**SUBDIVISION &  
ZONING AMENDMENT STAFF REPORT****Date: January 17, 2019**

<b><u>APPLICANT NAME</u></b>	Gary D.E Cowles (Cowles, Murphy, Glover & Associates)
<b><u>SUBDIVISION NAME</u></b>	Bean Commercial Subdivision
<b><u>LOCATION</u></b>	5580 & 5590 Todd Acres Drive North side of Todd Acres Drive, 2/10 mile ± West of Commerce Boulevard West
<b><u>CITY COUNCIL DISTRICT</u></b>	Council District 4
<b><u>PRESENT ZONING</u></b>	B-5, Office-Distribution District and I-1, Light Industry District
<b><u>PROPOSED ZONING</u></b>	I-1, Light Industry District
<b><u>AREA OF PROPERTY</u></b>	2 Lots/ 31.8± Acres
<b><u>CONTEMPLATED USE</u></b>	Subdivision Approval to create a two lots of record from three legal lots of record; and Rezoning from B-5, Office- Distribution District, and I-1, Light-Industry District to I-1, Light Industry District. <b>It should be noted, however, that any use permitted in the proposed district would be allowed at this location if the zoning is changed. Furthermore, the Planning Commission may consider zoning classifications other than that sought by the applicant for this property.</b>

# PROPOSED DETAIL SITE PLAN

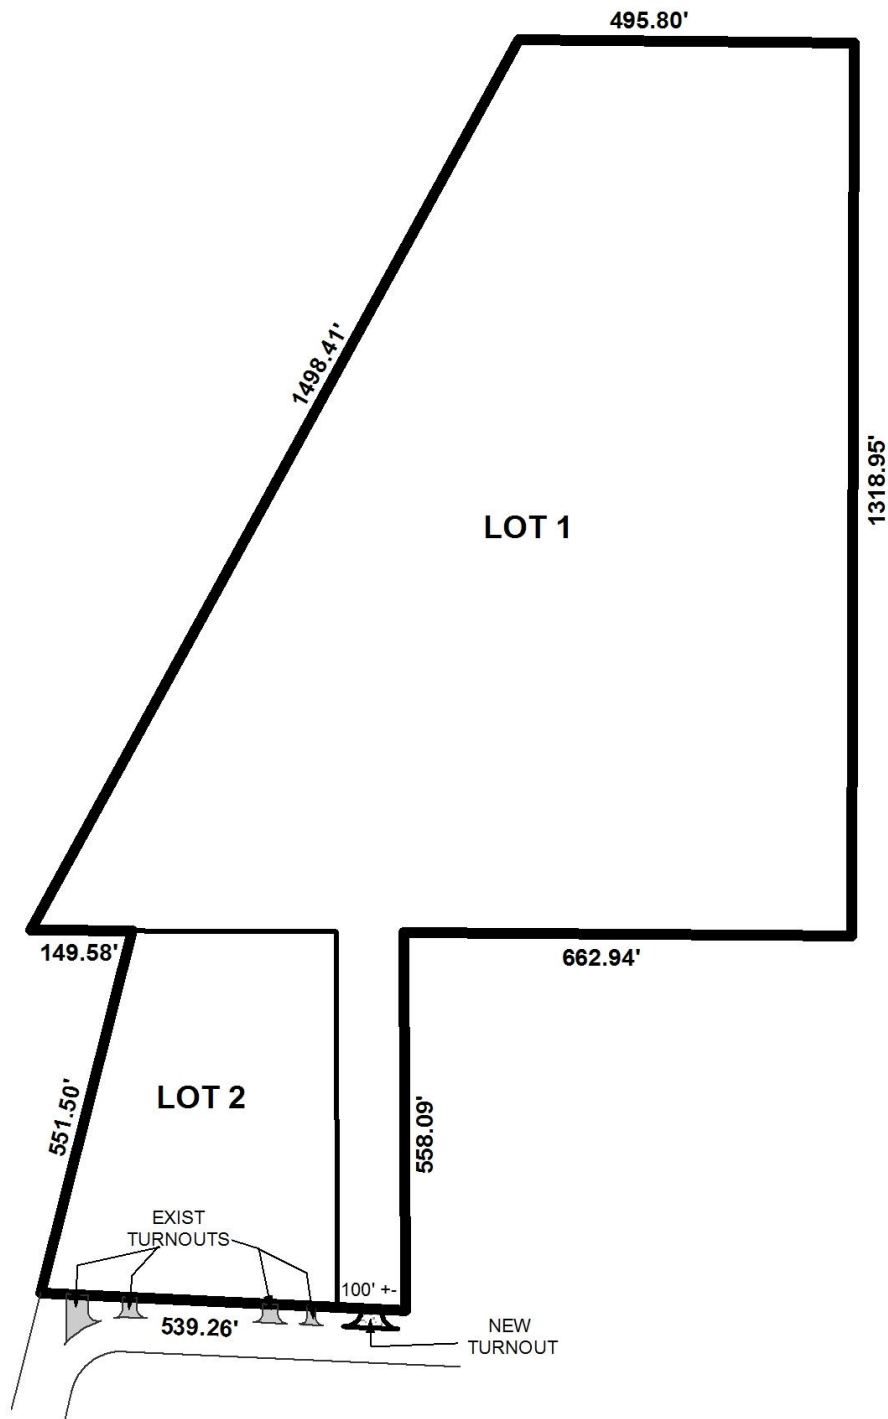
The preliminary plat does not illustrate the 25' minimum building setback lines nor does the site plan. If approved, the plat should be revised to depict the 25' minimum building setback lines on both lots where the lots abut road frontage, and/ or where they are a minimum of 60 feet in width.

The site appears to have two existing curb-cuts to Todd Acres Drive. The applicant is requesting a total of four curb-cuts to Todd Acres Drive with one curb-cut for Lot 1 and 3 curb-cuts for Lot 2. As a means of access management, the number, size, location and design of curb-cuts are to be approved by Traffic Engineering and conform to AASHTO standards.

Although the site was previously approved for the construction of the warehouse, the current site plan submitted does not clearly depict the square footage of the warehouse, number of warehouse employees, total number of parking spaces, tree planting and landscaping, or dumpster location. It should be noted full site compliance is required.

The site plan also indicates an outside storage and truck maneuvering area that is proposed to have aggregate surfacing, which is allowed in I-1, Light Industrial.

- 1) retention of the lot sizes in square feet and acres;
- 2) revision of the plat to depict the 25' minimum building setback lines for both lots;
- 3) full compliance with Engineering comments: *"FINAL PLAT COMMENTS (should be addressed prior to submitting the FINAL PLAT for review and/or signature by the City Engineer): A. Provide all of the required information on the SUBDIVISION PLAT (i.e. signature blocks, signatures, certification statements, written legal description, required notes, legend, scale, bearings and distances) that is required by the current Alabama State Board of Licensure for Professional Engineers and Land Surveyors. B. Provide reference, on the map and the description, to a monumented corner. C. Provide and label the monument set or found at each subdivision corner. D. Provide a vicinity map. E. Provide a written legal description and matching bearing and distance labels for the proposed subdivision. F. Show and label the existing lot lines. G. Add a signature block for the Owner, Notary Public, Planning Commission, Traffic Engineer, and City Engineer. H. Provide the Surveyor's Certificate and Signature. I. Provide the Surveyor's, Owner's (notarized), Planning Commission, and Traffic Engineering signatures. J. Add a note to the SUBDIVISION PLAT stating that a Land Disturbance permit will be required for any land disturbing activity in accordance with Mobile City Code, Chapter 17, Storm Water Management and Flood Control; the City of Mobile, Alabama Flood Plain Management Plan (1984); and, the Rules For Erosion and Sedimentation Control and Storm Water Runoff Control. K. Add a note to the Plat stating that the approval of all applicable federal, state, and local agencies (including all storm water runoff, wetland and floodplain requirements) will be required prior to the issuance of a Land Disturbance permit. L. Add a note that sidewalk is required to be constructed, and/or repaired, along the frontage of each lot, or parcel, at time of new development or construction, unless a sidewalk waiver is approved. M. Add a note to the plat stating that all proposed detention facilities, common areas, and wetlands shall be the responsibility of the Property Owner(s), and not the responsibility of the City of Mobile. N. Add a note to the plat stating that all easements shall remain in effect until vacated through the proper Vacation process. O. Provide a copy of the FINAL SUBDIVISION PLAT to the Engineering Dept. for review. No signatures are required on this drawing. P. After addressing all of the FINAL SUBDIVISION PLAT review comments by the Engineering Dept. provide the red-line markup, the ORIGINAL (with all other signatures) and one (1) copy of the revised original (signatures not required) of the revised Final Plat to the Engineering Department."*;

- 4) placement of a note on the site plan stating the following Traffic Engineering comments: *"Site Lot 1 is limited to one curb cut and Lot 2 is limited to the existing curb cuts with any changes in size, location and design to be approved by Traffic Engineering and conform*

*to AASHTO standards. Any new on-site parking, including ADA handicap spaces, shall meet the minimum standards as defined in Section 64-6 of the City's Zoning Ordinance."*
